## Draft Pyrmont Peninsula Place Strategy

Angela Wu Submission 12 September 2020

## **RE: COMMUNITY ENGAGEMENT - BLACKWATTLE BAY PRECINCT PLANNING**

### Diagram A - Height Plane Diagram

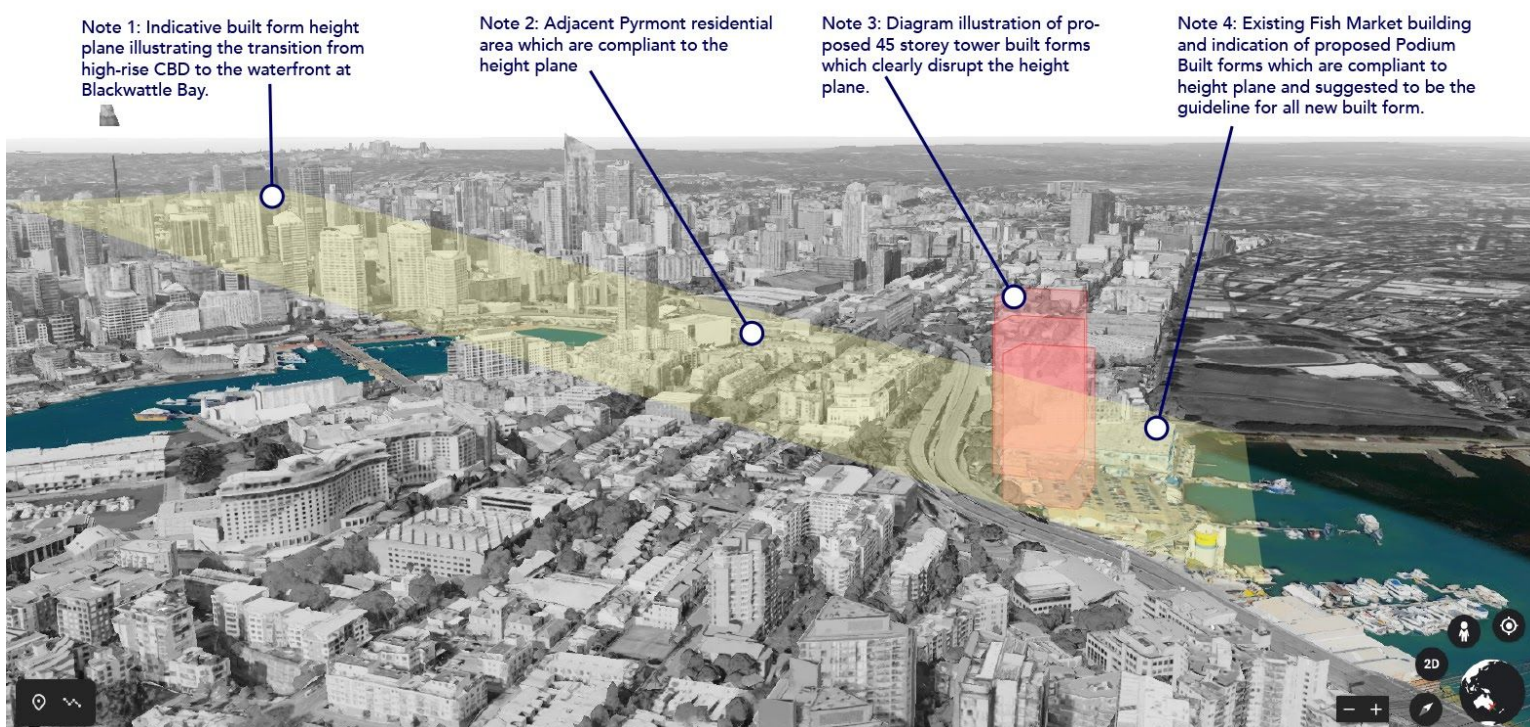
It is recommended that proposed built form be reviewed to reflect this concept of stepping down built form to the water. Heights of buildings should follow a natural fall in the height plane dictated by existing morphology as illustrated in Appendix A diagram A. The benefits of this includes:

This diagram was submitted as part of my BBP submission to demonstrate the disruption to the natural fall of the built form height planes that the Blackwattle Bay towers will bring. A similar concept can be applied to the Darling Harbourside tower proposals. The yellow plane roughly represents the idea of 'stepping down' to the water of Blackwattle Bay.

Diagram B - Developments that do not complement or enhance the area of Pyrmont.

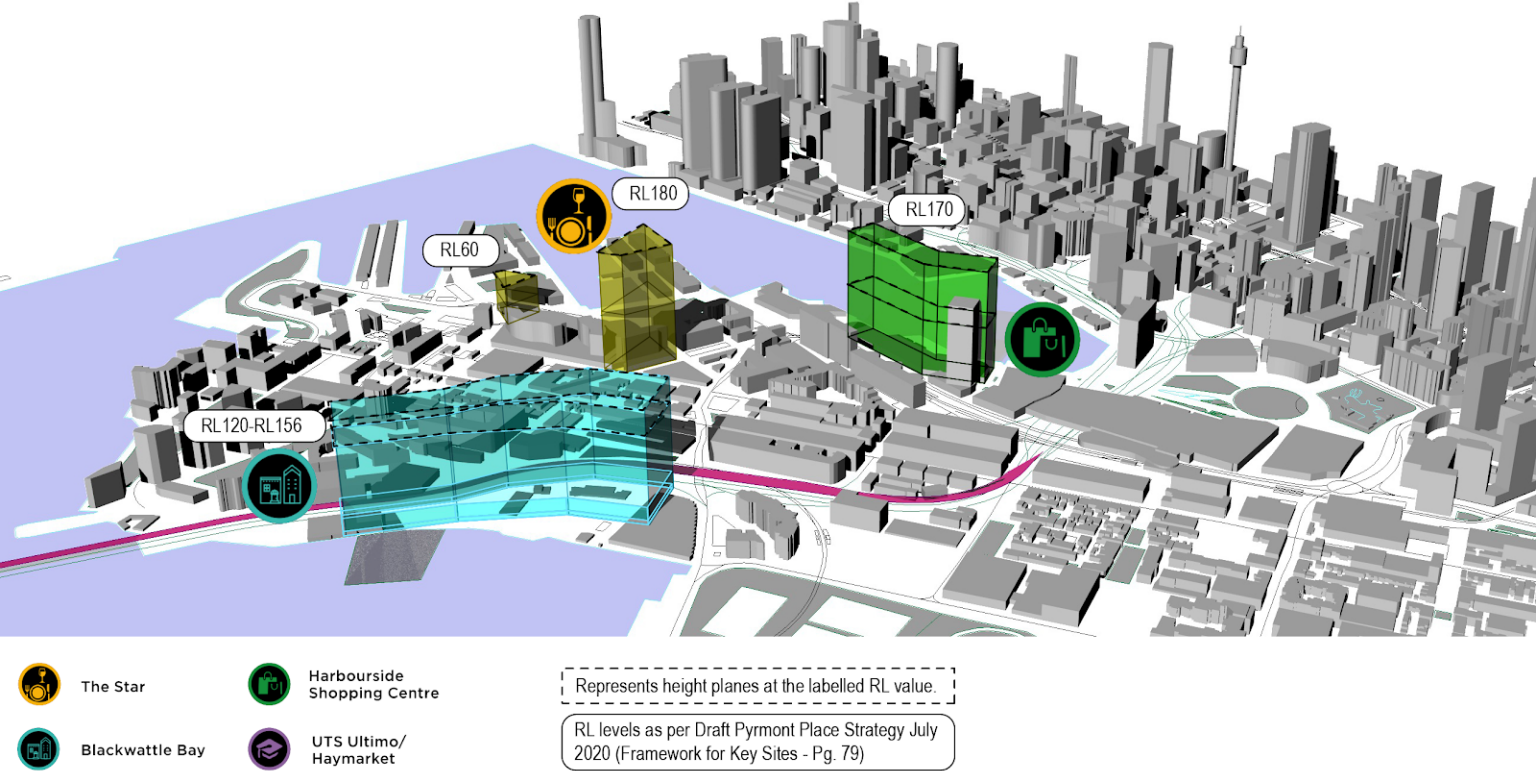
This diagram reflects a model of the proposed built form tower heights currently indicated by the PPPS and its impact on Pyrmont. The incongruous nature of these tower proposals are made more obvious in this diagram and clearly do not represent the principle of ‘development that complements or enhances that area’. The diagram clearly demonstrates that the heights proposed for these towee forms are more synonymous with the CBD in the background than the low-mid rise morphology of Pyrmont.
